CITY OF MERCER ISLAND

STAFF REPORT

SHORELINE SUBSTANTIAL DEVELOPMENT PERMIT

Project No.:	SHL23-014
Description:	Shoreline Substantial Development Permit to replace and reconfigure an existing residential pier and retroactively permit an existing dual personal watercraft lift.
Applicant / Owner:	Kristin Osterberg (Waterfront Construction, Inc.) / Eckhard Evers
Site Address:	4456 Ferncroft Road, Mercer Island, WA 98040; Identified by King County Assessor tax parcel number 004610-0453.
Zoning District:	Single Family Residential (R-15)
Staff Contact:	Andrew Leon, Planner
Exhibits:	<ol style="list-style-type: none">1. Development Application, dated January 10, 20232. Notice of Complete Application, issued by the City of Mercer Island on February 24, 20233. Notice of Application, issued by the City of Mercer Island on March 6, 20234. Development Plan Set, dated September 8, 20235. Project Narrative, dated July 21, 20236. Ecological No Net Loss Assessment Report, prepared by Northwest Environmental Consulting, LLC, dated revised September 20237. SEPA Checklist, updated February 2, 20238. SEPA Determination of Nonsignificance Issued by the City of Mercer Island on November 20, 2023

EXISTING SITE PLAN

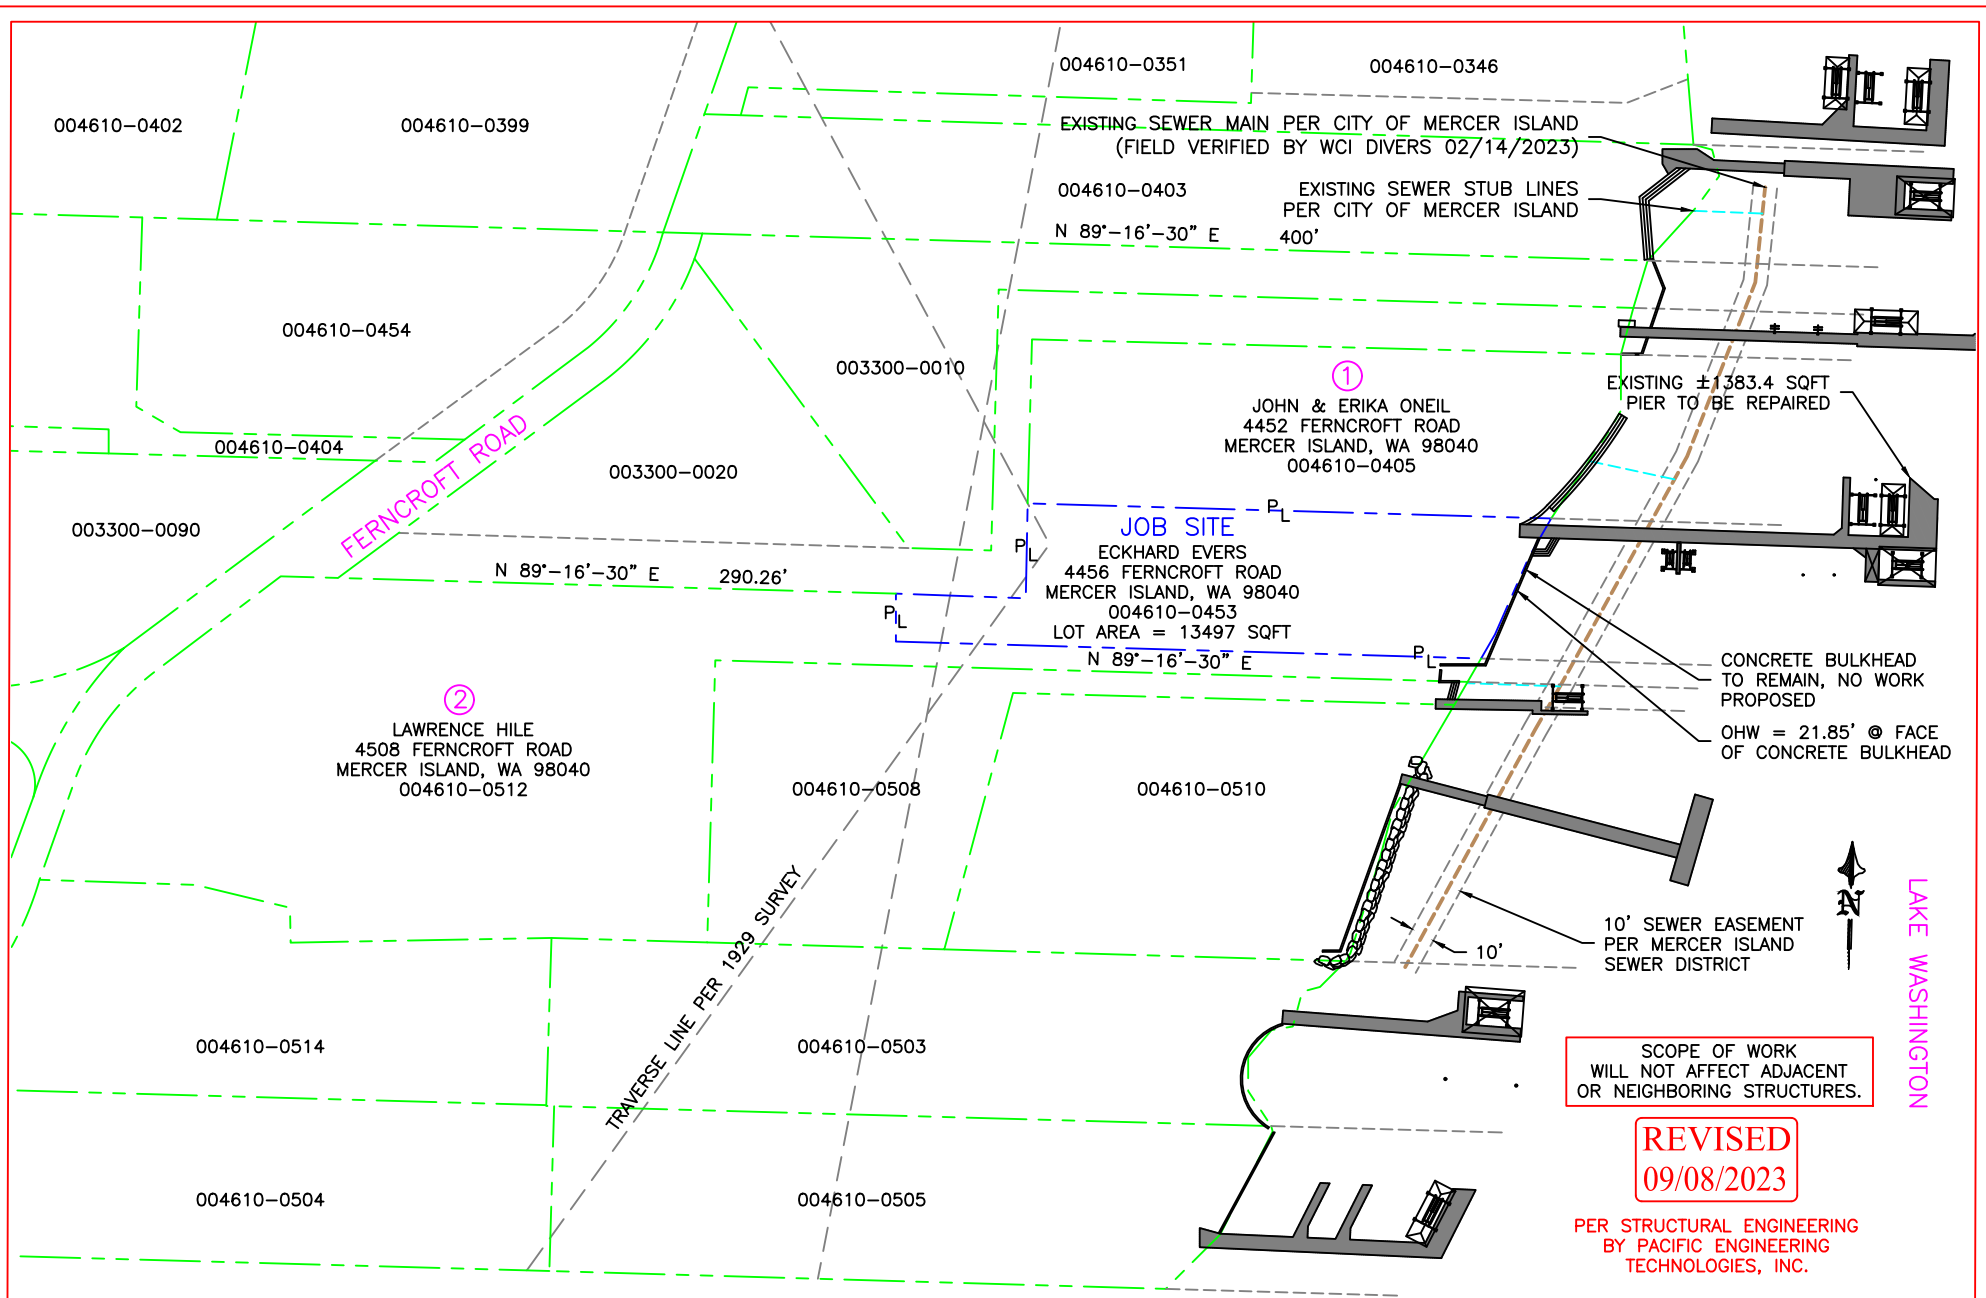
Staff Analysis: As shown in Exhibit 4, the existing pier is located within the 10-foot setback from the south lateral line. MICC 19.13.020(B) states that expansions to legal nonconforming overwater structures are permitted, provided that the expanded portion of the structure is constructed in compliance with Chapter 19.13 MICC and all other standards and provisions of the MICC. The proposed dual personal watercraft lift and a portion of the new finger pier are proposed to be located on the south side of the existing pier, further from the lateral line than the existing pier.

Staff Analysis: Exhibit 4 shows that the existing pier extends 174 feet waterward from the OHWM. MICC 19.13.020(B) states that expansions to legal nonconforming overwater structures are permitted, provided that the expanded portion of the structure is constructed in compliance with Chapter 19.13 MICC and all other standards and provisions of the MICC. Exhibit 4 shows that the proposed addition to the pier will be no more than 150 feet waterward of the OHWM and that the water depth within 150 feet waterward of the OHWM is less than 11.85 feet. This standard is met.

PROPOSED SITE PLAN

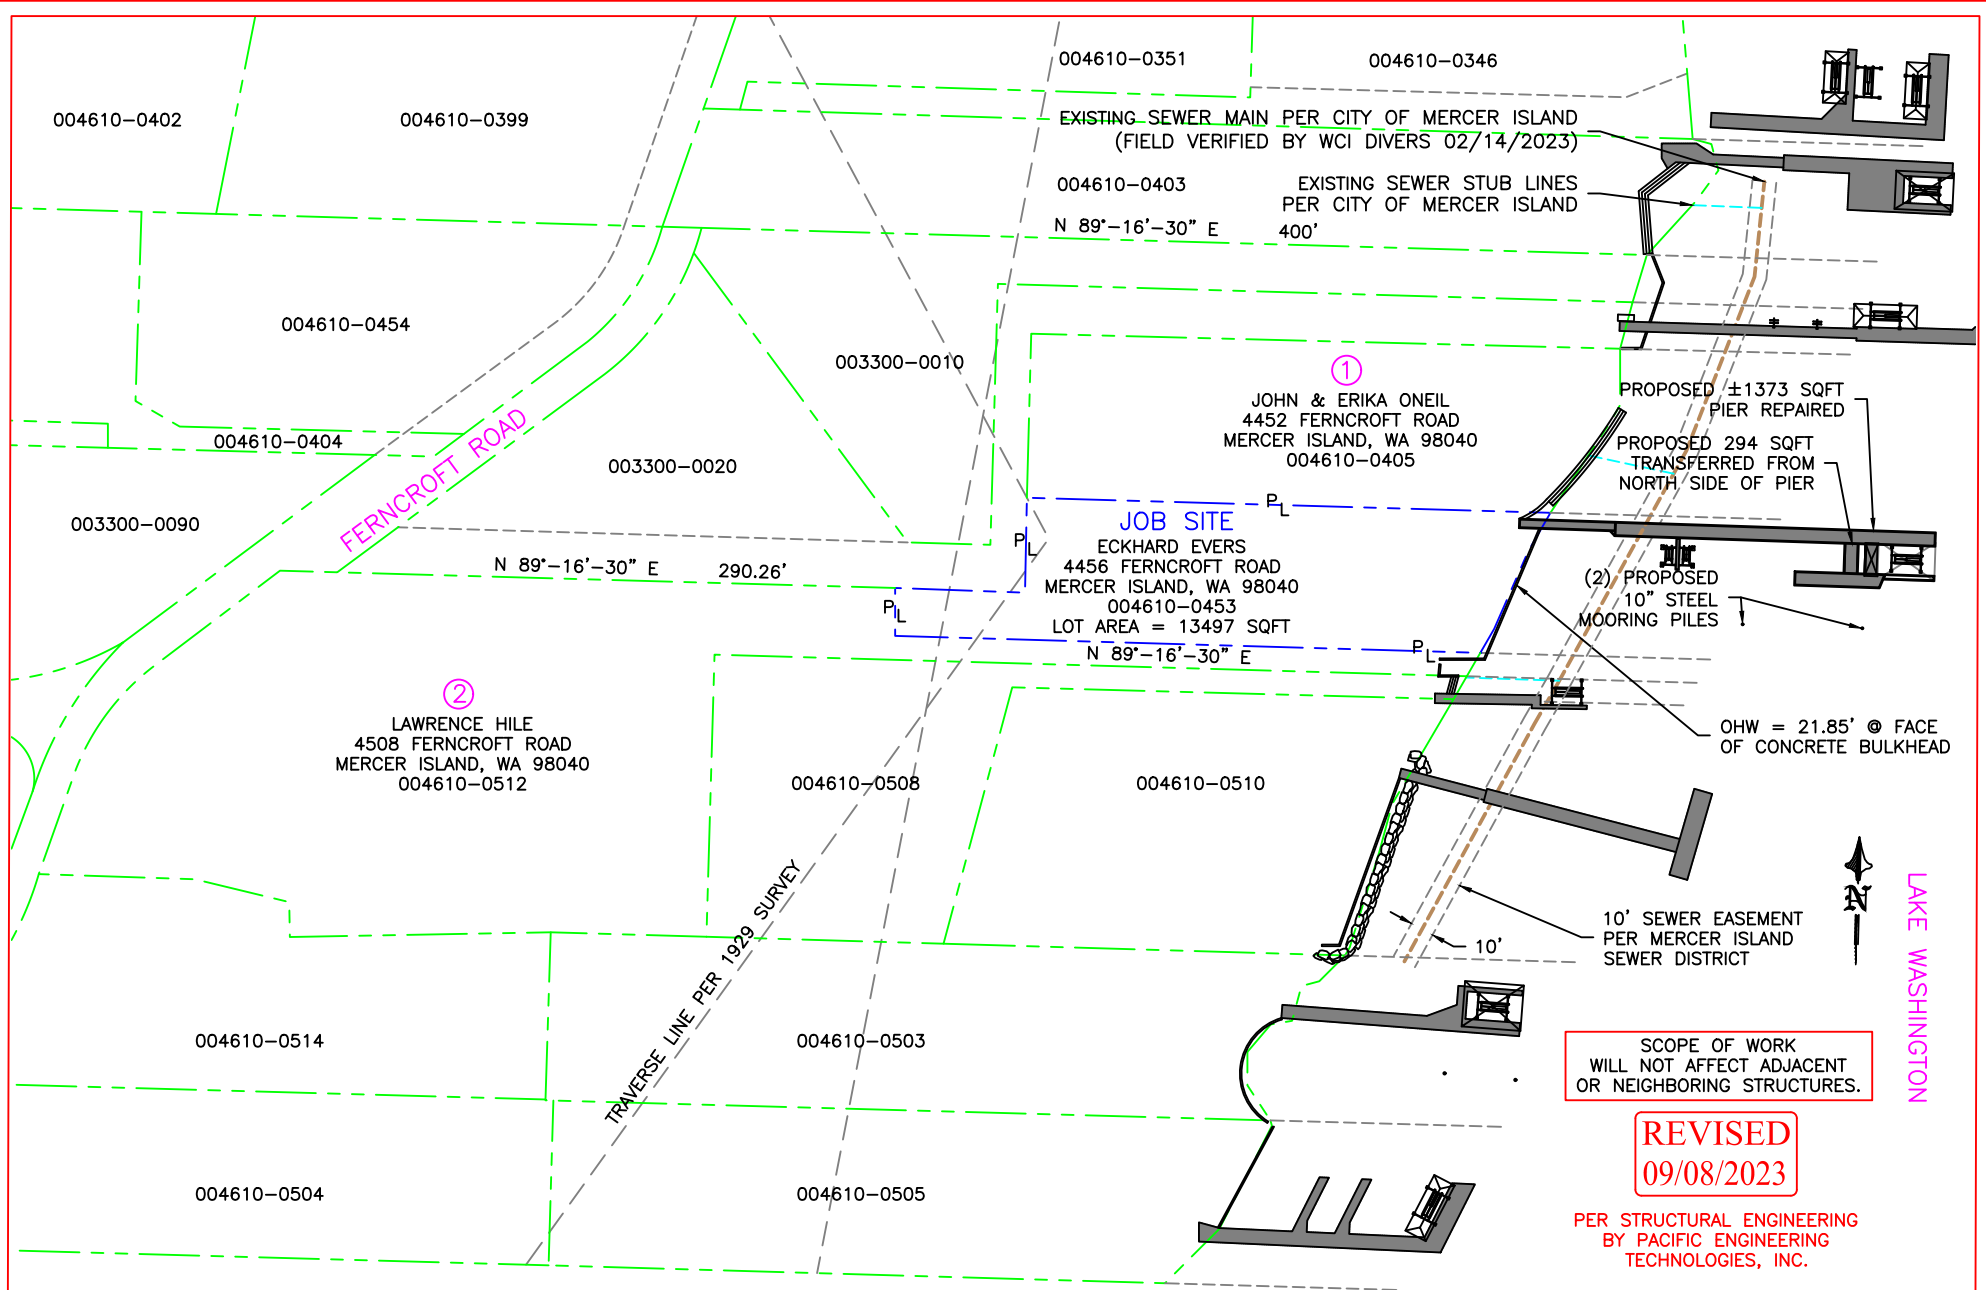
Staff Analysis: Exhibit 4 shows that the proposed pier is to be four feet in width within the first 30 feet waterward of the OHWM. This standard is met.

Staff Analysis: Exhibit 4 shows that all portions of the pier and the finger piers are no more than six feet in width more than 30 feet waterward of the OHWM. This standard is met.

REFERENCE #:		
APPLICANT: ECKHARD EVERS		
PROPOSED: PIER REPAIR		
SHEET: 6	OF: 14	NEAR/AT: MERCER ISLAND
DATE: 06/28/2022	DWG#: 21-32061-A6-6

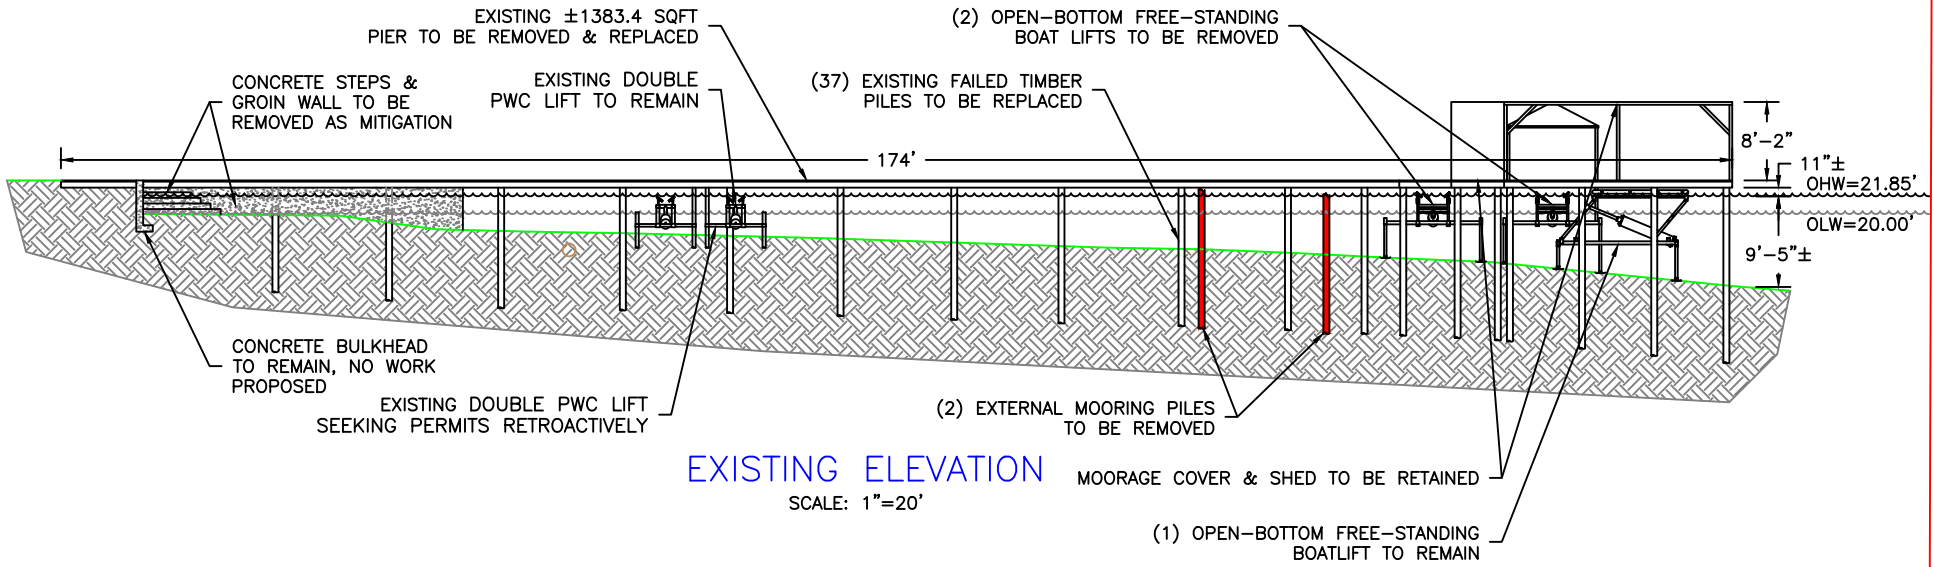
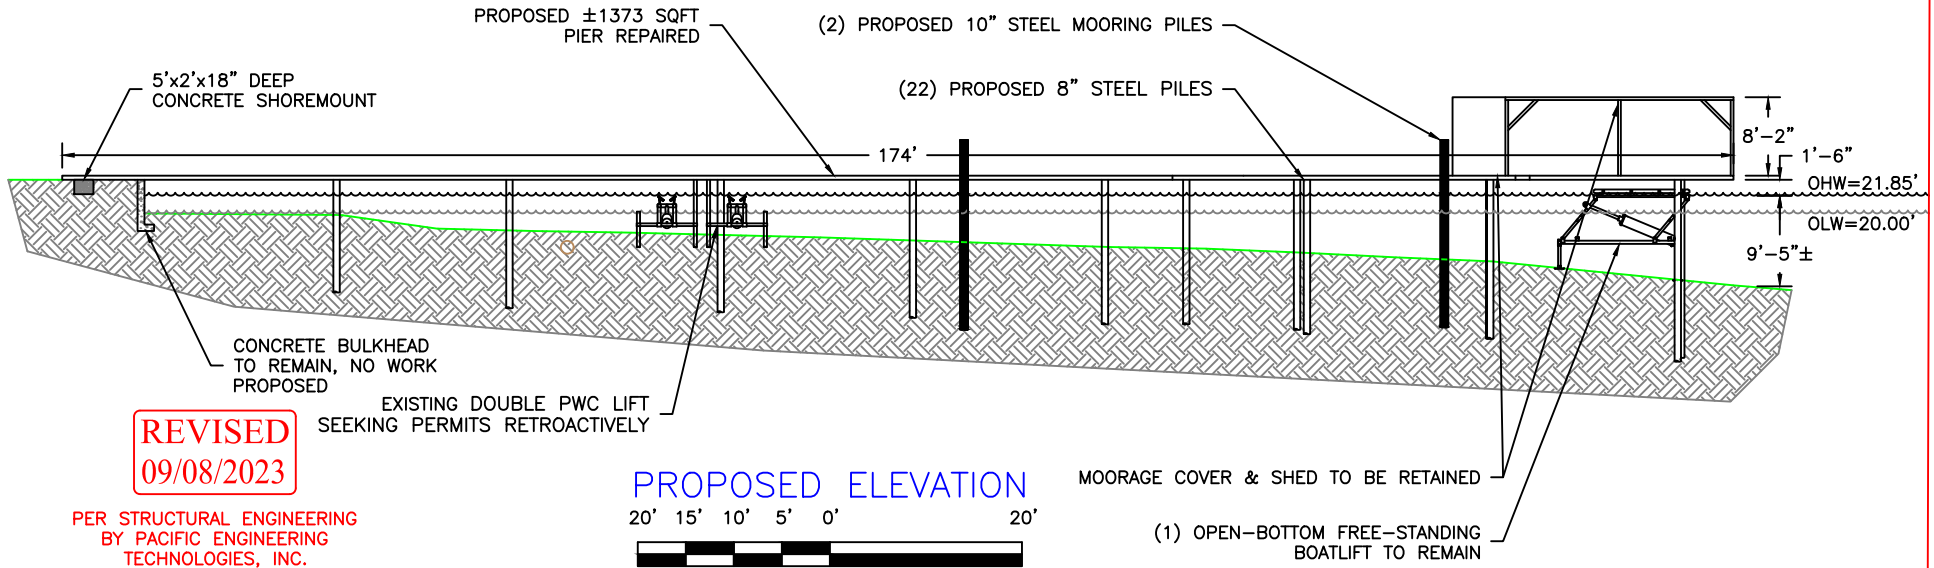
Staff Analysis: The elevation view on Sheet 6 of Exhibit 4 shows that the pier does not include walls, rails, or storage containers. This standard is met.

Staff Analysis: The elevation view on Sheet 6 of Exhibit 4 shows that the proposed mooring piles extend less than ten feet above the OHWM. This standard is met.
